Access Compliance Report

Public Rights-of-Way

(Curb Ramps)

Intersection ID: 13184	Main Street: S_MINT_ST	Cross Street: S_MINT_ST	Location: NW
ADA ID: F0E8BDBEA9F0	Ramp Type: PerpDiag	Initial Pass/Fail: Fail	Overall Compliance: No
Severity Score: 21.25			
Codes/Mitigation Info/Possible Solution		Field Measurements/Component Compliance

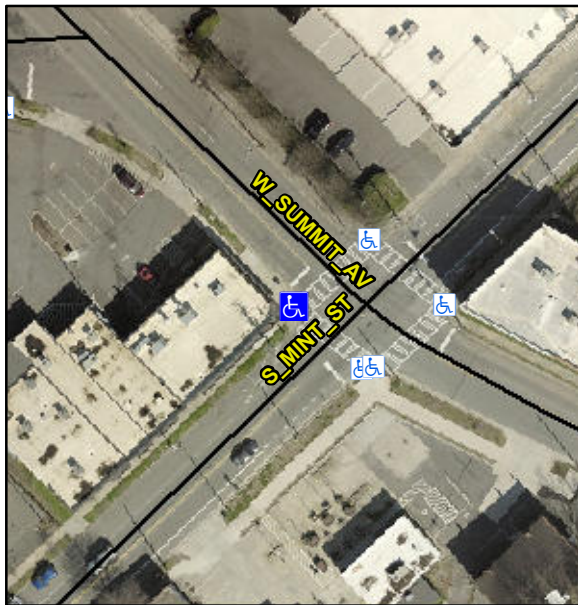
Not Found, R304.5.1, R304.2.2

Compliance	Description	Data	Compliance	Description	Data
N/A	Ramp Length (in)	64.0	No	Ramp Slope (%)	11.4
No	Ramp Width (in)	47.0	Yes	Ramp XSlope (%)	0.8
N/A	Flare Type LT	N/A	N/A	Flare Type RT	N/A
N/A	Flare Slope LT (%)	N/A	N/A	Flare Slope RT (%)	N/A
N/A	Flare Traversable LT?	N/A	N/A	Flare Traversable RT?	N/A
N/A	Landing Length (in)	N/A	N/A	DWS Provided?	N/A
N/A	Landing Width (in)	N/A	N/A	DWS Contrast?	N/A
N/A	Landing Slope (%)	N/A	N/A	DWS Length (in)	N/A
N/A	Landing X Slope (%)	N/A	N/A	DWS Full Width?	N/A
N/A	Landing Curb? (Y/N)	N/A	N/A	DWS Offset (in)	N/A
N/A	Shared Landing?	N/A			
N/A	Gutter Ponding?	N/A	N/A	Gutter Slope (%)	N/A
N/A	Gutter Lip Ht (in)	N/A	N/A	Gutter X Slope (%)	N/A
N/A	Painted X Walk1?	Yes	N/A	Painted X Walk2?	Yes
	X Walk 1 Direction	To SE		X Walk 2 Direction	To NE
N/A	X Walk 1 Width (in)	108.0	N/A	X Walk 2 Width (in)	108.0
	X Walk 1 Slope (%)	4.7		X Walk 2 Slope (%)	3.3
	X Walk 1 X Slope (%)	2.7		X Walk 2 X Slope (%)	5.2

Remove & Replace Curb Ramp With Two New Directional Ramps or Equivalent.
